RE: Objection to proposed development of 11-23 Rangers Avenue Mosman (SSD-96272465)

1.1. This submission is prepared by the owner of 28 Holt Avenue, in response to the proposed development of 11-23 Rangers Avenue (SSD-96272465) by Grand Noble Project 1 Pty Ltd (the Applicant). Our home is immediately to the north of the proposed development site. We object to the proposed development on the following ground:

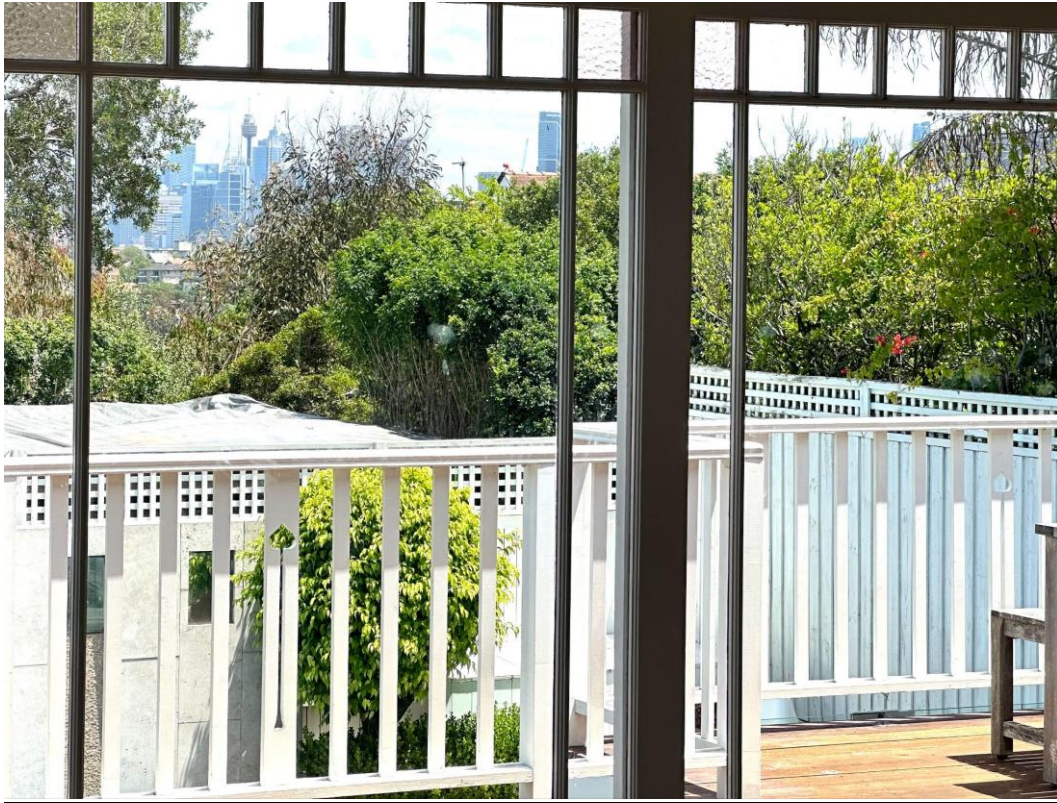
- 3.6. Step 1: assessment of views to be affected: The Applicant correctly identifies that the proposed development will affect views of the CBD skyline. Our property has views of the CBD skyline, including the iconic Centrepont Tower.

Image taken on 11/12/2025 while standing on the balcony adjacent to our open-plan kitchen and living area. Views of Centrepont Tower and CBD skyline are clearly visible and significant. We will be entirely deprived of these iconic views, as well as views of the sky by the massive and imposing bulk and height of the proposed development.

Image taken on 11/12/2025 while standing inside our open plan- kitchen and living area. Views of Centrepont Tower and CBD skyline clearly visible and significant. We will be entirely deprived of these iconic views, as well as the sky by the massive and imposing bulk and height of the proposed development.

CLIENT: ANGELA BROOKS			PROJECT: 11-23 RANGERS AVENUE, MOSMAN, NSW		
SURVEYED MO			TITLE: PLAN SHOWING DISTANCE FROM CREMORNE TOWN CENTRE TO 11-23 RANGERS AVENUE		
DRAWN MO			DATE 04/12/2025		
CHECKED ME			SCALE: 1:1250		
SHEET 1 OF 6			DRAWING No. 25639001		
A1			REV 02

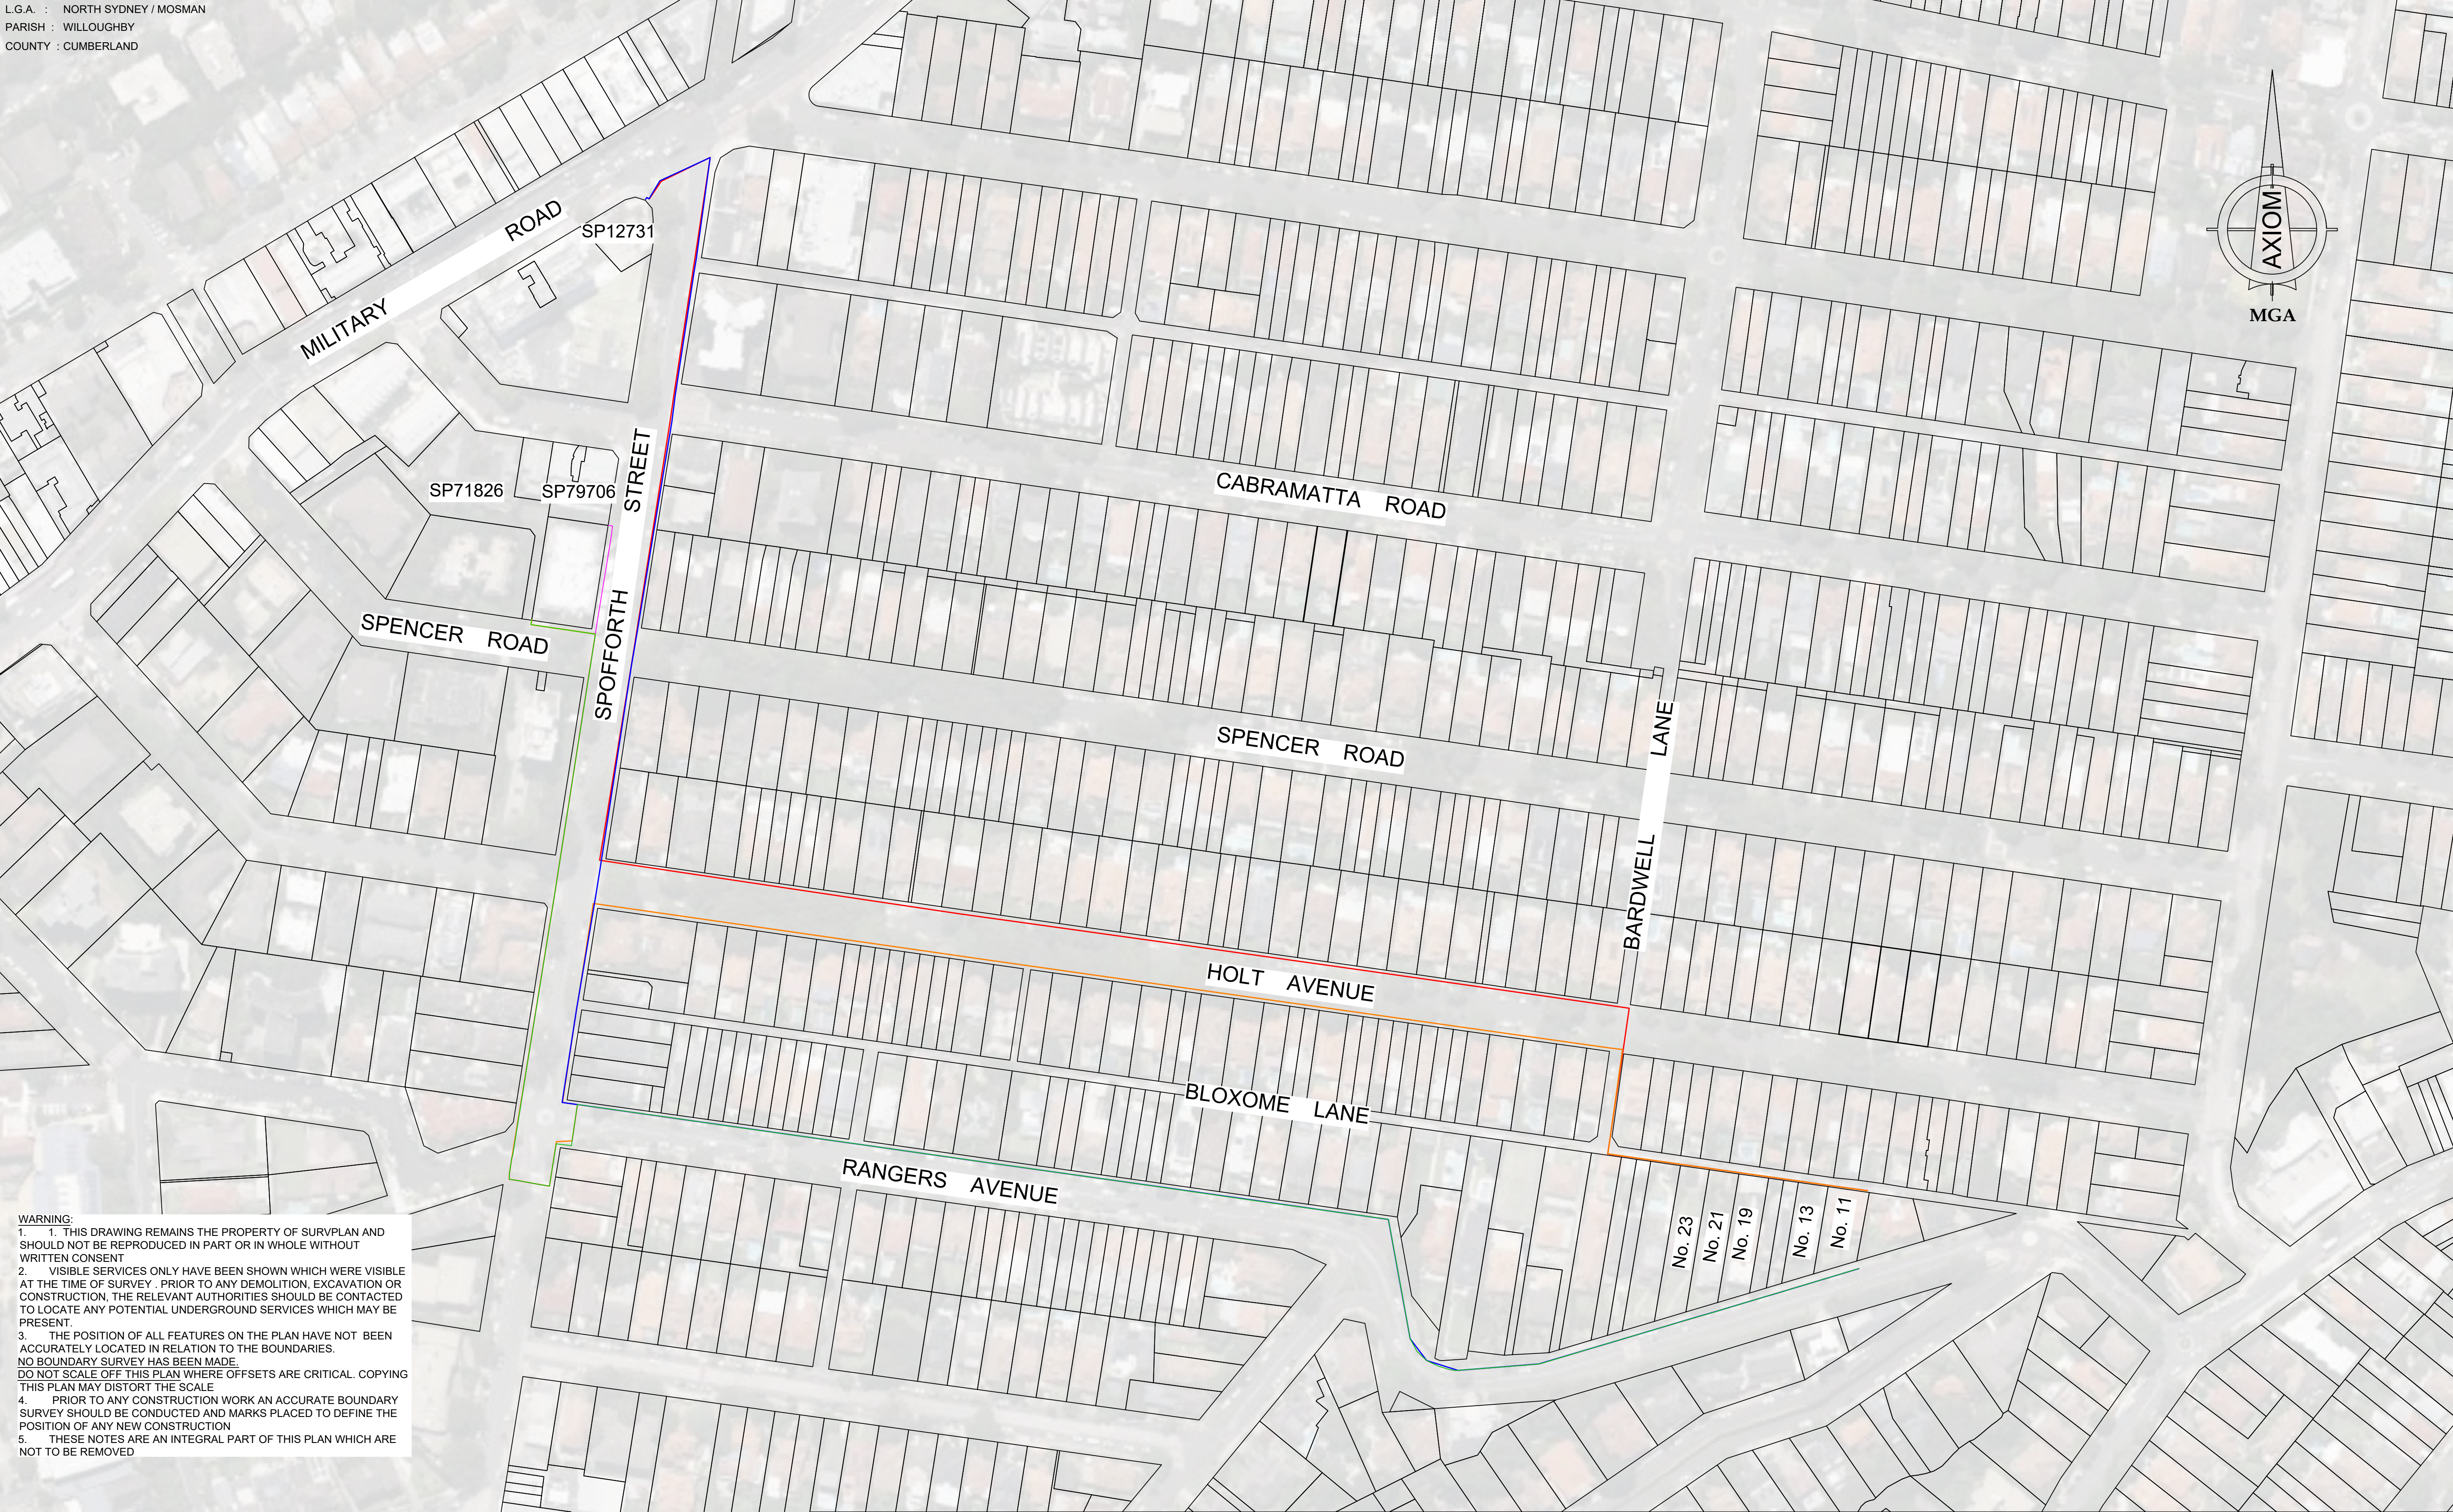
- 2.7. We have obtained an expert report from a surveyor (**Annexure A**), which demonstrates that there are two pedestrian crossings that would be reasonably practicable to use: the intersection of Spofforth St and Cranbrook Ave; and the intersection of Spofforth St and Military Rd. The definition of "walking distance" requires the routes to utilise pedestrian crossings when reasonably practicable. It would obviously be reasonably practicable to use either of those pedestrian crossings when walking to the Cremorne Town Centre. **When either pedestrian crossing is used, the proposed development is not within 800m of the Cremorne Town Centre**. Therefore it is **not within the low and mid rise housing outer area**. As set out in Annexure A, the distances from Cremorne Town Centre to 23 Rangers Avenue using the suitable and safe pedestrian crossings range from 918.1m to 814.7m.

FIGURE 2: SEVERITY GUIDANCE SHEET – AUSTRROADS

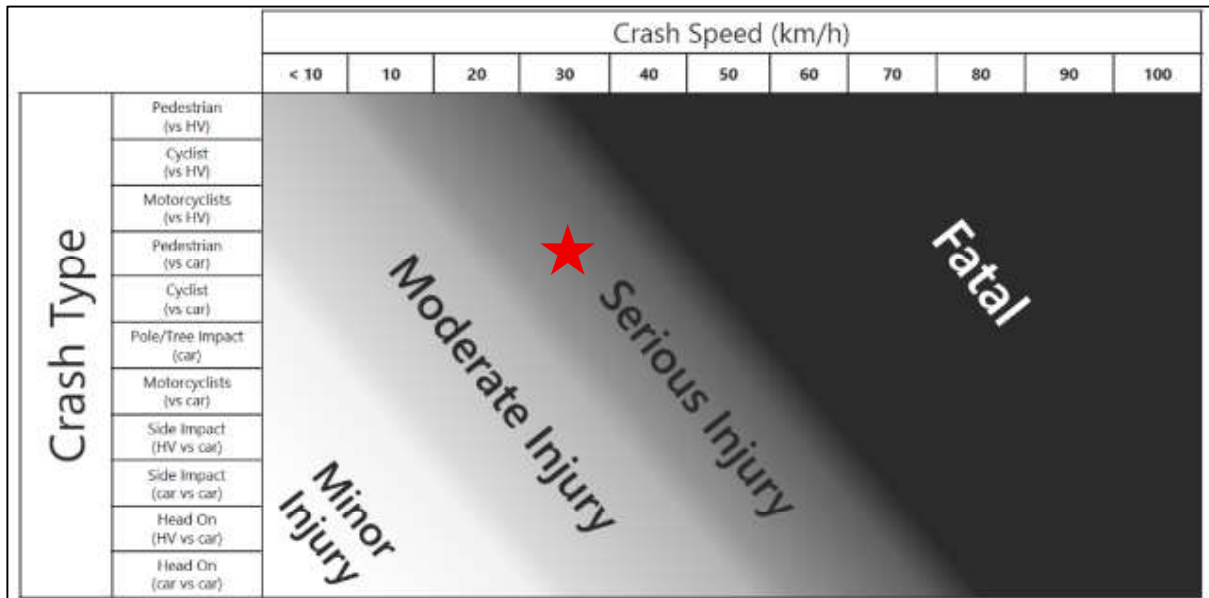
There is a risk of a pedestrian strike where a pedestrian accepts an unsafe gap to cross the road. Given the gaps available, it is possible that the crossing is unlikely to give an approaching enough time to stop before colliding with the pedestrian. The severity of a pedestrian strike is based on the guidance sheet as provided in the *Austrroads Guide to Road Safety Part 6*, which is reproduced as **Figure 2** below that is referenced after considering both the likelihood (refer to **Table 3**) and the severity (refer to **Table 4**) of a crash or collision between a pedestrian and an approaching vehicle.

A vehicle would likely decelerate in anticipation of a pedestrian strike. It is reasonable to assume that at the point of impact, a vehicle would be traveling approximately 30km/h. As shown, in **Figure 3** an incident involving a pedestrian and a car at speeds between 30km/h can cause serious injuries. Although the incident may be rare, serious injuries indicate a **medium** risk level and exceeds the Safe System crash outcome threshold. Safety conscious planning is the term generally applied in the minds of accredited road safety auditors who are listed on the following website <https://www.roadsafetyregister.com.au>.
